[Docket No. 91-ANE-29; Amendment 39-9470; AD 91-21-01 R1]

Airworthiness Directives; Textron Lycoming Model TIO-540-S1AD Reciprocating Engines

ACTION: Final rule; request for comments.

APPENDIX 1

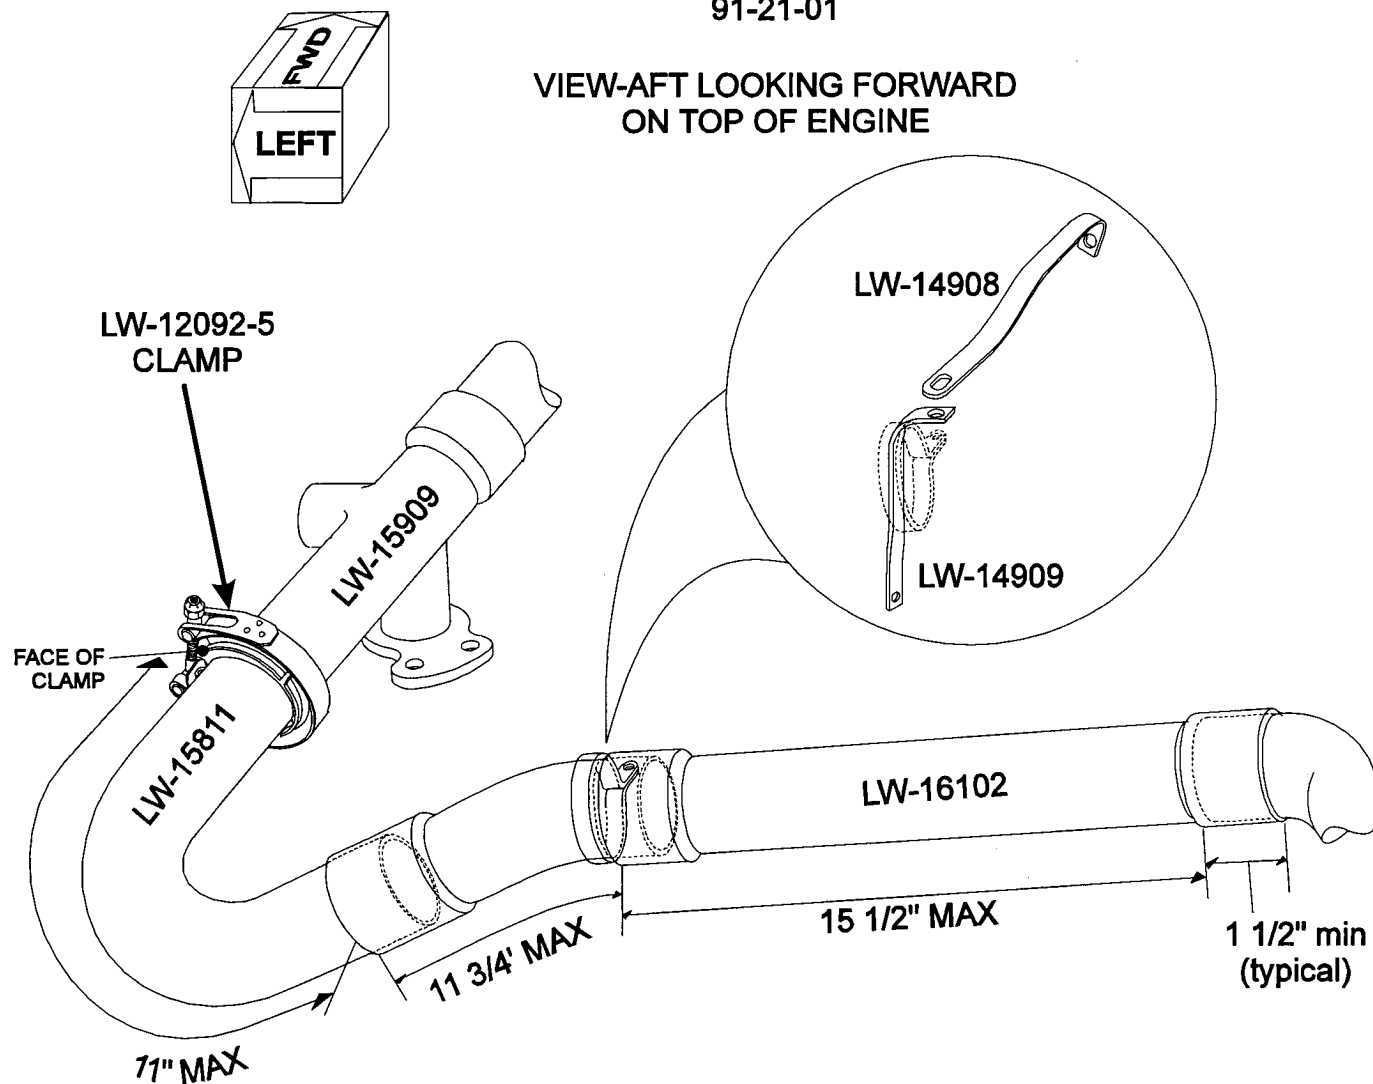
(ii) Inspect the exhaust system for proper slip joint engagement by measuring distances between pipe end points in accordance with Appendix 1 of this AD.

(ii) Thereafter, at intervals not to exceed 100 TIS, perform exhaust system inspections specified in paragraph (a)(2)(i) and (a)(2)(ii) of this AD. Operators need determine the minimum engagement of only exhaust pipes LW-16102 and LW-16103 by referring to Appendix 1 of this AD.
